STAFF RECOMMENDATION 1229 Sixth Avenue North February 17, 2016

Application: Partial demolition; New construction—Addition; Setback determination
District: Germantown Historic Preservation Zoning Overlay
Council District: 19
Map and Parcel Number: 08209026400
Applicant: Michael Emrick
Project Lead: Melissa Baldock, melissa.baldock@nashville.gov

Description of Project: Application is to demolish an existing addition and construct a new addition that is taller than the historic house. The addition requires a setback determination. Base zoning requires a three foot side setback, but the addition will be one foot (1') or less from the side property line.

Figure 8. The 1897 Sanborn map shows a different addition and possibly a porch at the location of the existing addition.

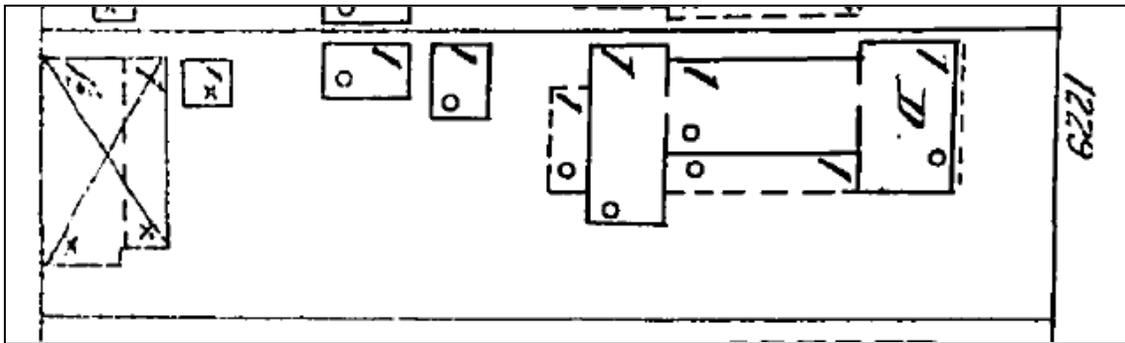
Partial Demolition. The applicant proposes to demolish an existing addition at the rear of the house (Figures 2 – 7). The date of construction of the addition is not known. The 1897 Sanborn Map shows an addition in the location of the existing addition, but that addition does not cover the entire width of the rear of the house and its dotted line indicates that it was a porch (Figure 8). The 1914 Map seems to show that the addition existed at that time (Figure 9). Although the addition does likely date to the early 20th century, it is located at the rear of the house, and is barely visible from the street. It lacks the architectural detail of the rest of the house. Staff finds that it does not contribute to the historic character of the house and to the Germantown Historic Zoning Overlay as a whole. Staff therefore finds that its demolition meets Section 7.2.2. for appropriate demolition and does not meet Section 7.2.1. for inappropriate demolition.

SITE PLAN
1" = 10'-0"

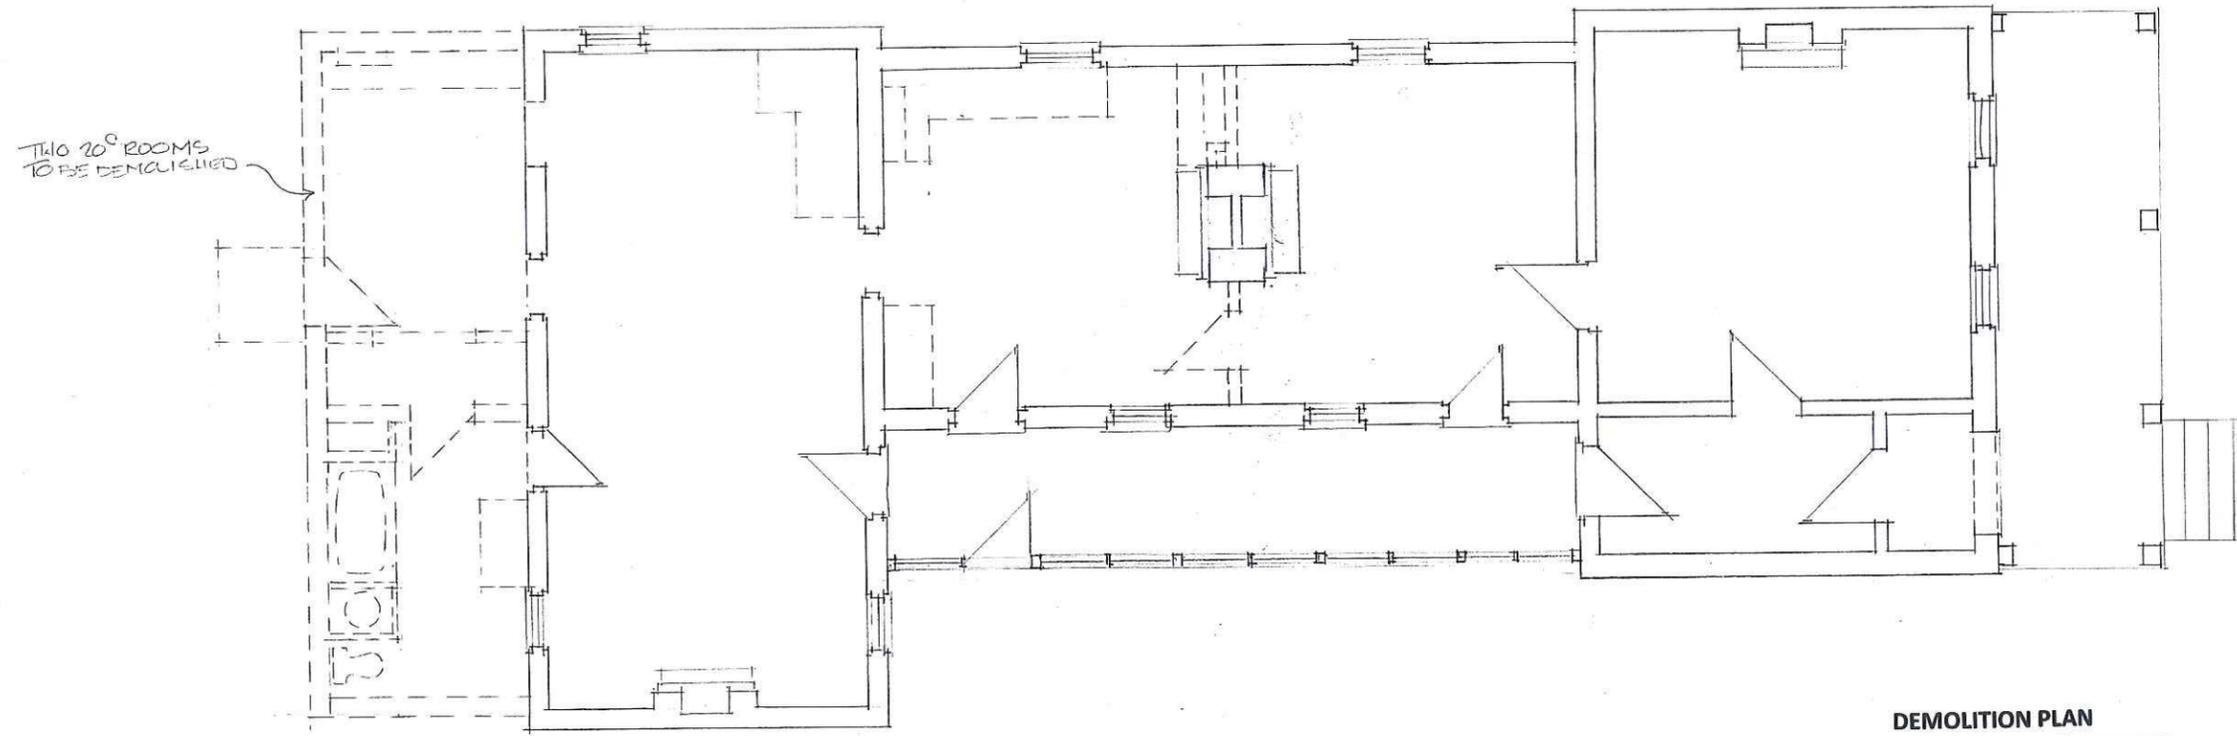
Setback. The addition requires a setback determination for the right/north side. The site is zoned MUN. Base zoning requires that for a single family residence, the side setbacks be three feet (3'). The existing house is shifted towards the right/north side of the lot. It is situated approximately one foot (1') from the right/north side property line. The addition lines up with the historic house, and is therefore also approximately one foot (1') from the property line on the right/north side. Staff finds the proposed one foot (1') setback to be appropriate because the addition will not encroach any further into the setback than the historic house. In addition in the Germantown neighborhood, historically houses were located on or very close to side property lines. Lastly, in MUN zones, base zoning allows for a zero setback if the structure is multifamily. Staff therefore finds that the proposed setback determination meets Sections 2.2.1. and 4.2. of the design guidelines.
